| Project | IEEE 802.16 Broadband Wireless Access Working Group < http://ieee802.org/16 > | |
| Title | Sampling rate change for OFDM | |
| Re: | Support material for comment in Letter Ballot 4a | |
| Abstract | It is proposed to change the over-sampling ratio in OFDM mode from 7/6 to 8/7 | |

Figure 1 PSD with 8/7 over-sampling ratio

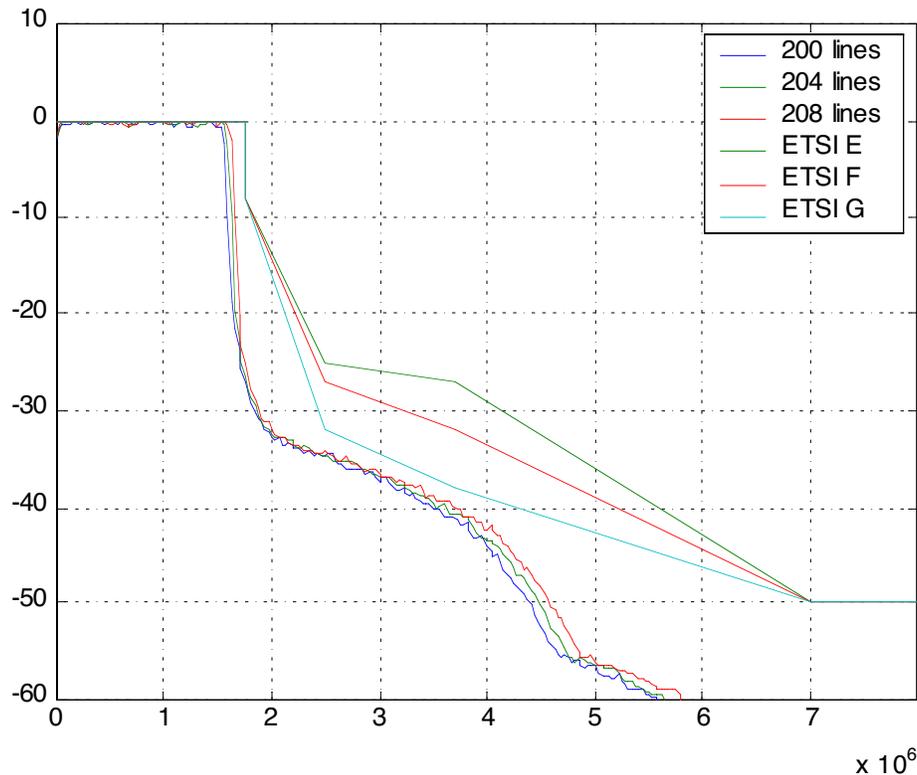
When going from 7/6 to 8/7 we can use the 2% reduction in bandwidth to increase the number of pilots. This issue is brought here for consideration, *however it may be considered independently of the issue of sampling rate change.*

The number of pilots can be increased from 8 to 12 or 16 pilots, resulting in a total of 204 or 208 subcarriers. The effect of this on the spectral density is shown in Figure 1, where the spectrum of an OFDM waveform with $F_s/BW=8/7$ consisting of 200, 204 and 208 carriers is shown. It is assumed that a power amplifier with 8 dB back-off was used. The ETSI TDMA type E-G masks are also shown for reference.

It is shown the even with 208 carriers there is still margin for frequency errors.
